BMW Motorrad USA

Service Information Bulletin

Subject: Shift Assistant

Models: S 1000 XR (K49)

► Checking serial number for shift assistant

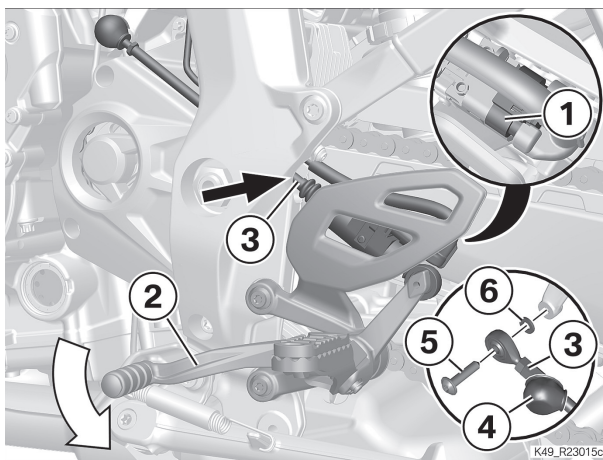
- Check production date **(1)** and production serial number **(2)**.
- List of affected shift assistants with production date **(1)** and production serial number **(2)**.
 - 26.05.2015: 3-108
 - 27.05.2015: 1-104
 - 28.05.2015: 1-138
 - 29.05.2015: 1-125
 - 01.06.2015: 1-89
 - 02.06.2015: 1-20
 - 03.06.2015: 1-4

Production date and production serial number match the list of affected shift assistants.

- Renew the shift assistant.
